MAZDA/FORD GF4A-EL/GF4EAT HARSH UPSHIFTS

COMPLAINT: 1993 & up, vehicles equipped with GF4A-EL transaxles, built before 1/3/95, may exhibit a harsh 1-2 upshift or harsh upshift complaints before or after overhaul. Line pressure appears to be normal or slightly higher than normal when checking in the "D" range. "Normal" line pressure readings are as follows, 60-78psi. at idle and 161-172 psi. at stall.

Figure 1

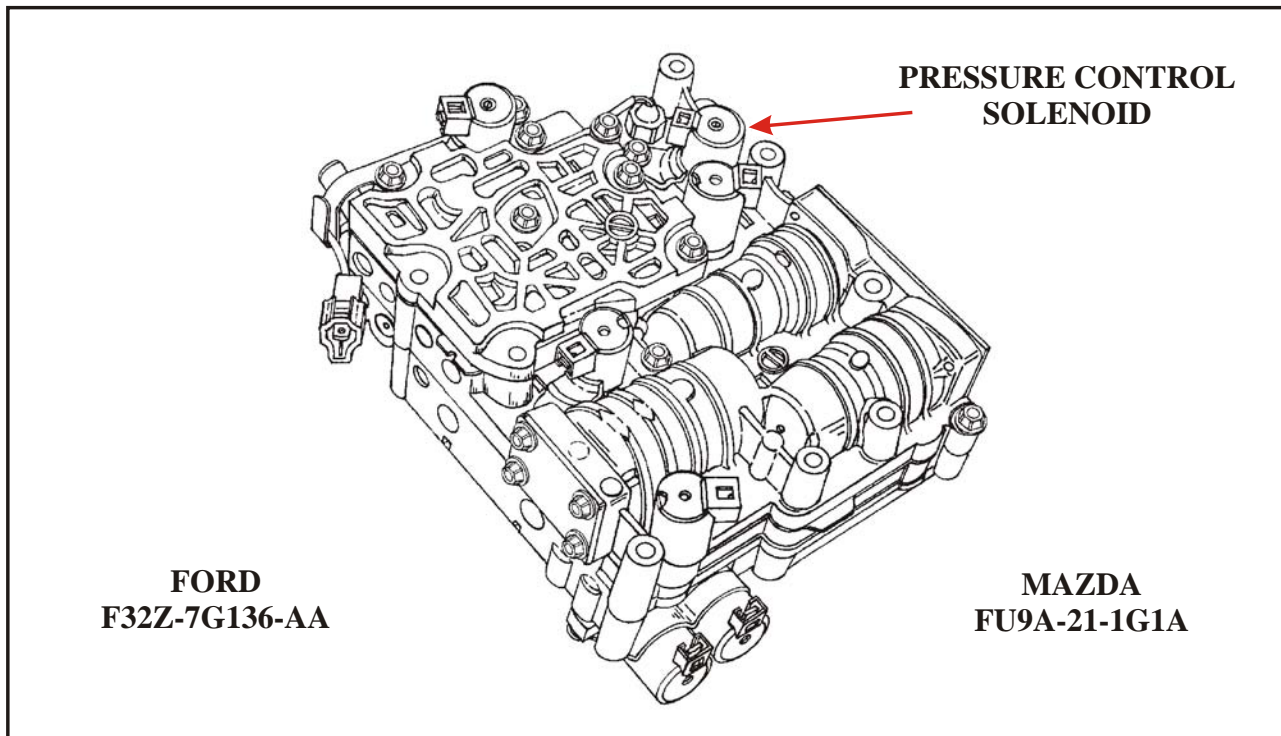
CORRECTION: Replace the Pressure Control Solenoid as shown in Figure 1 with Ford part number F32Z-7G136-AA or Mazda part number FU9A-21-1G1A. Inspect the Pressure Regulator Valve and the Pressure Regulator Valve bore for wear or scoring. Inspect the Boost Valve and Boost Valve Sleeve for wear or scoring. Ensure that there is no *"side to side"* wobble of the Pressure Regulator Valve, when it is in its bore. See Figure 2. Enlarge the Pressure Regulator *"balance"* orifice in the rear control spacer plate to .056" as shown in Figure 3.

PRESSURE CONTROL SOLENOID (FORD).....F32Z-7G136-AA

PRESSURE CONTROL SOLENOID (MAZDA).....FU9A-21-1G1A

Figure 3

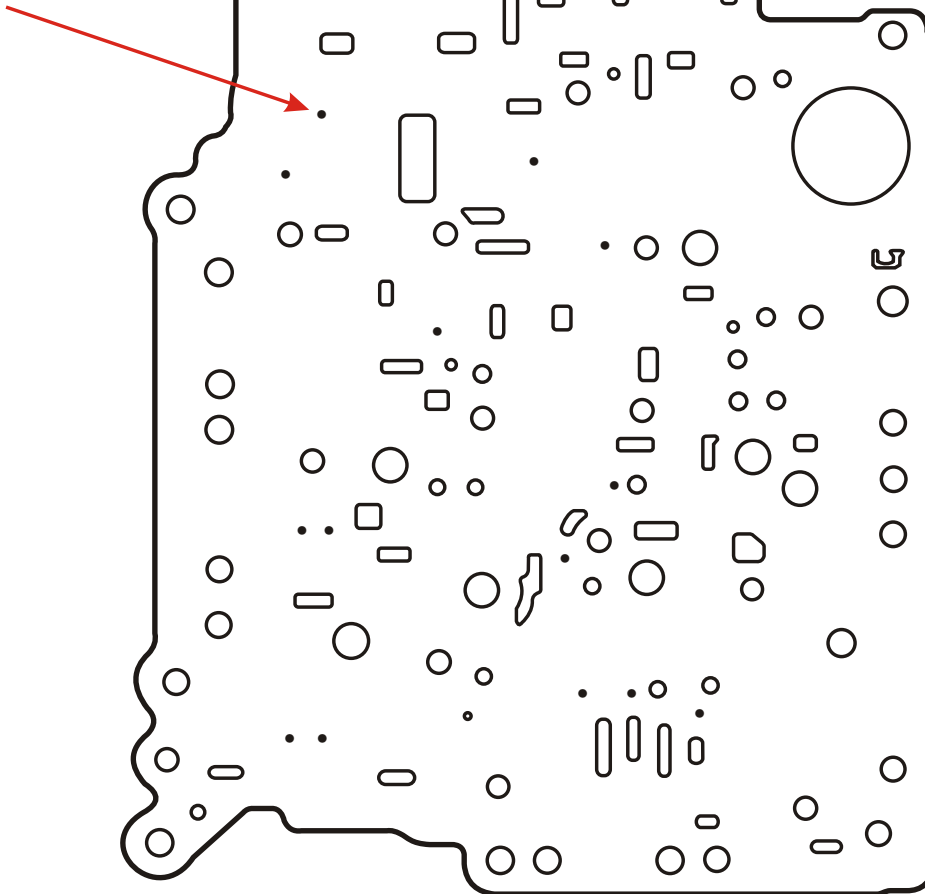
ENLARGE THIS
ORIFICE TO .056"
